# CITY OF ALBUQUERQUE

**Re: Freddy's  
131 Coors Blvd NW  
Requested for 60-Day Permanent C. O. - Accepted  
Engineers Stamp Date 7/7/15 (K10D001B)**

**GRADING AND  
DRAINAGE PLAN**

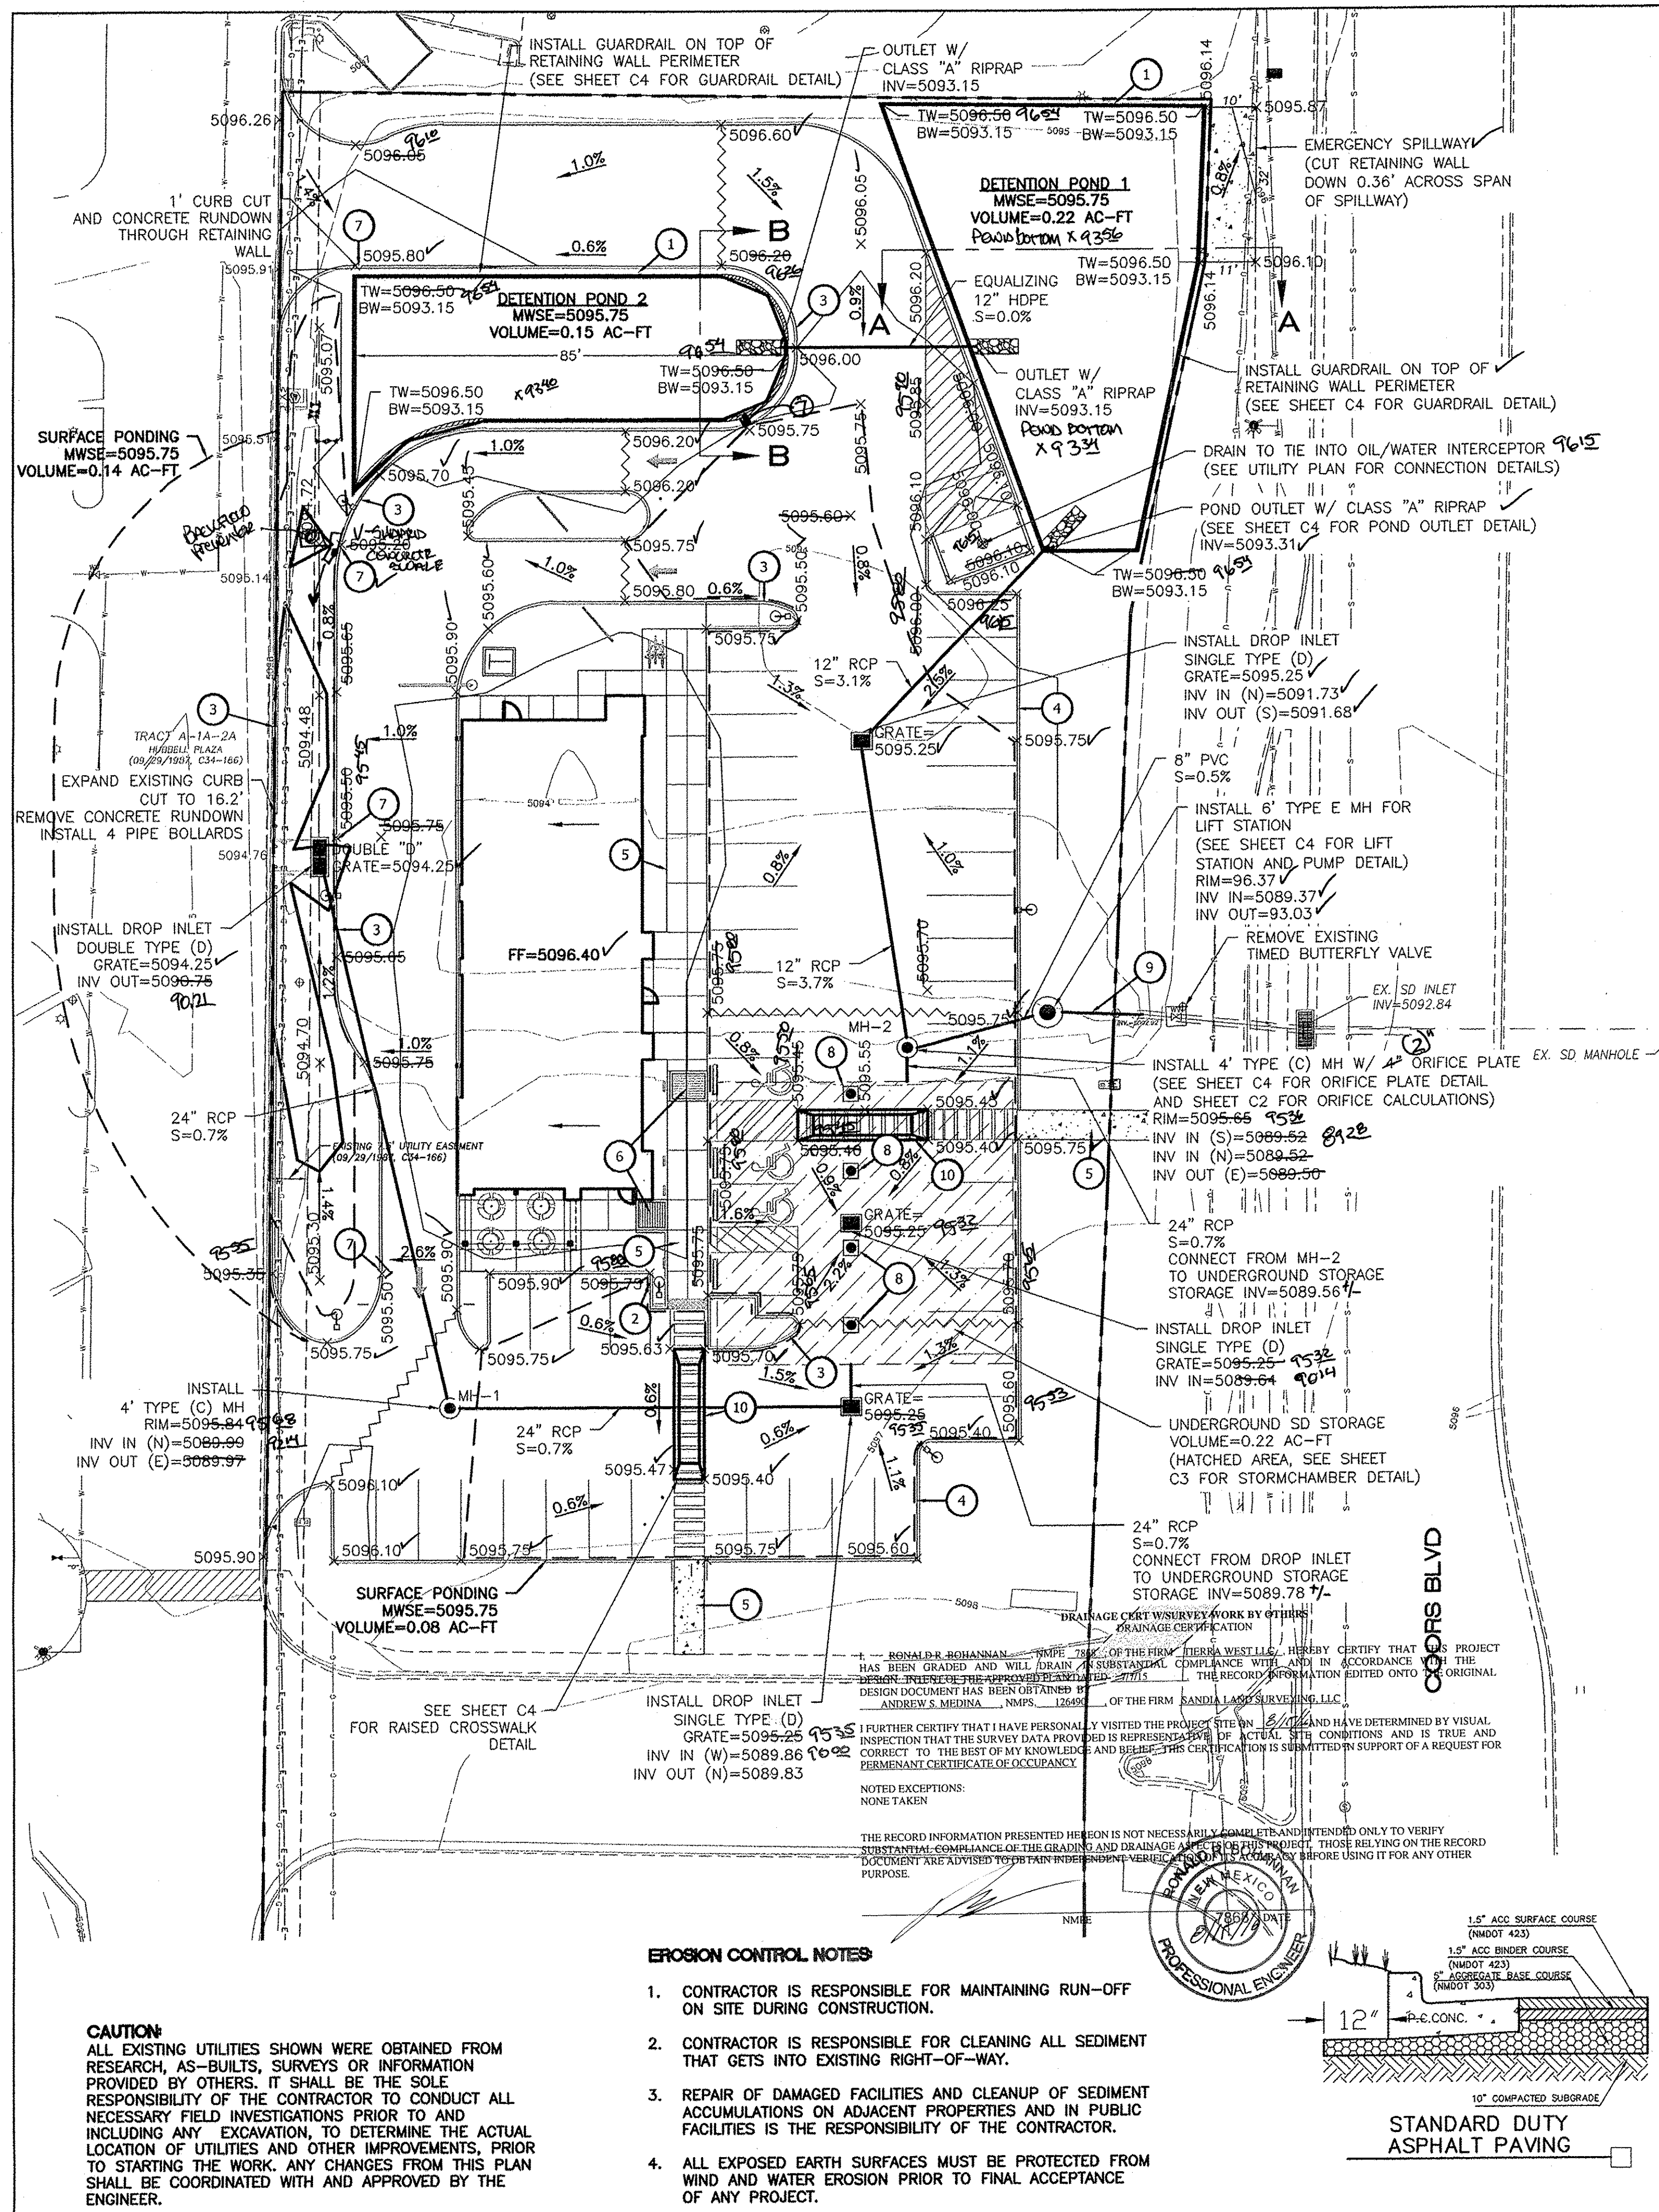
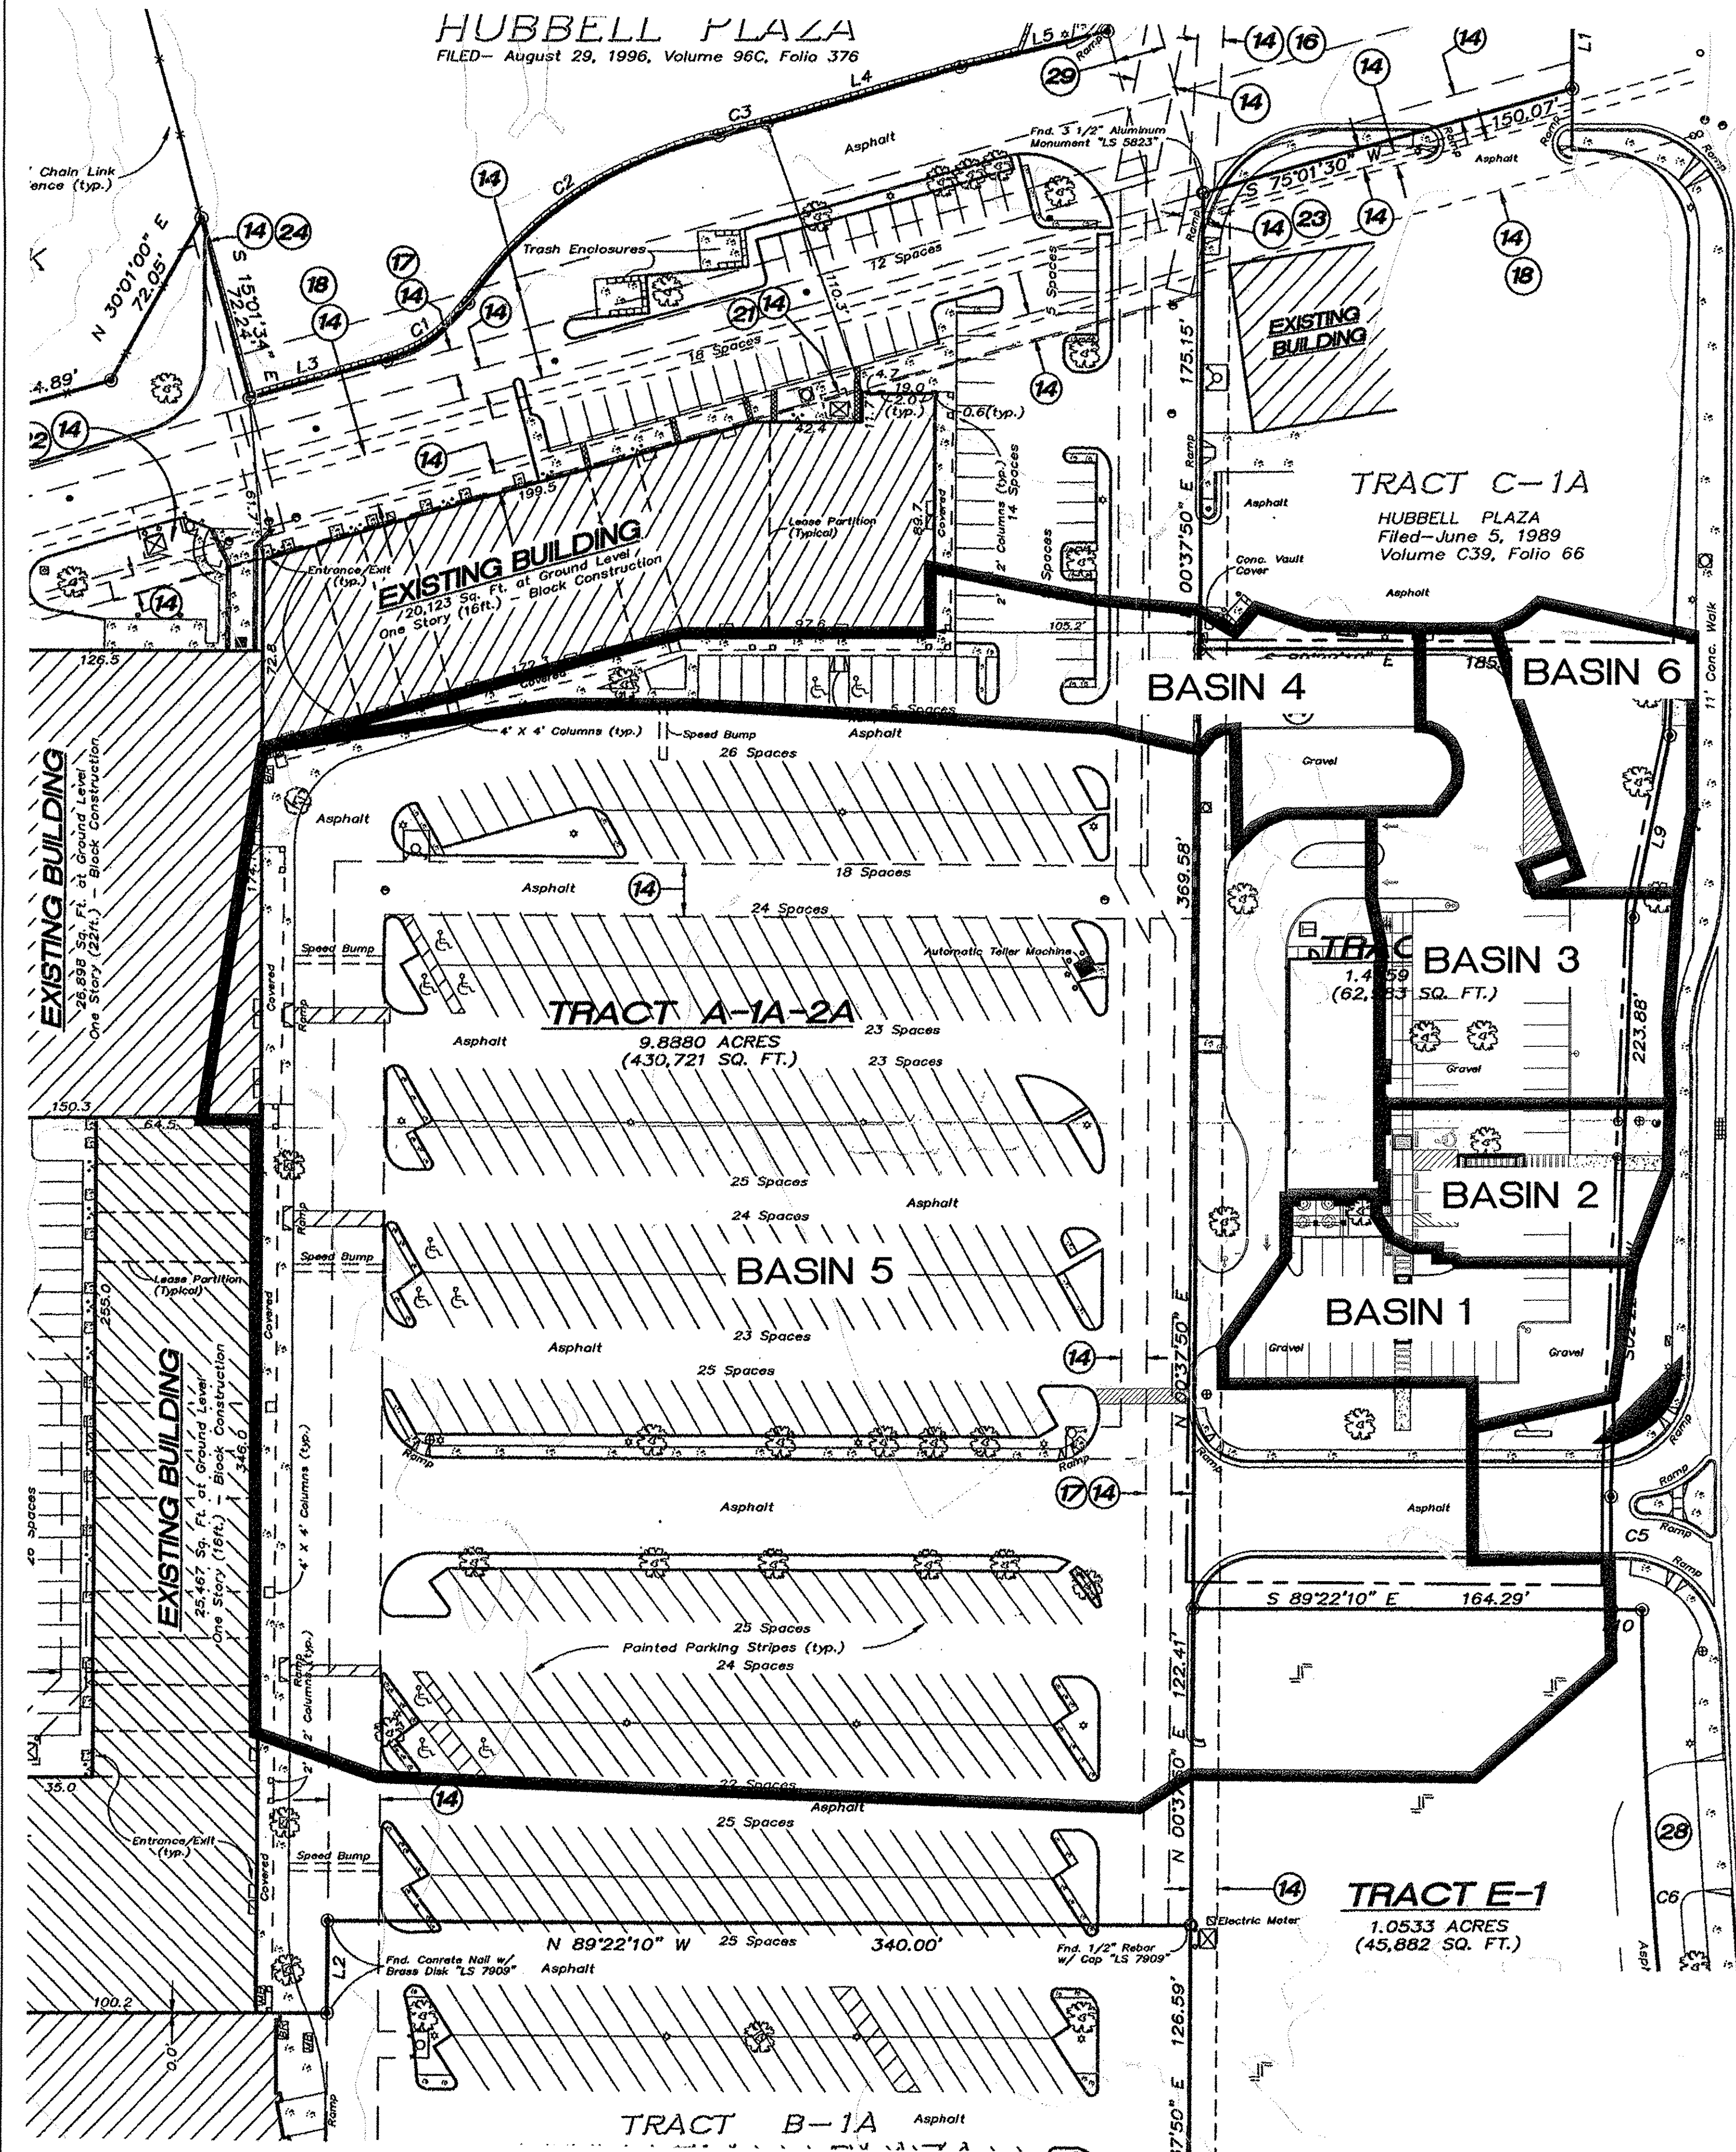
- The Emergency Spillway appears to flow back into the pond. Per the drawings the flow was towards the NE corner of the spillway. Should the ponds every completely fill up the water may back flow into the site.
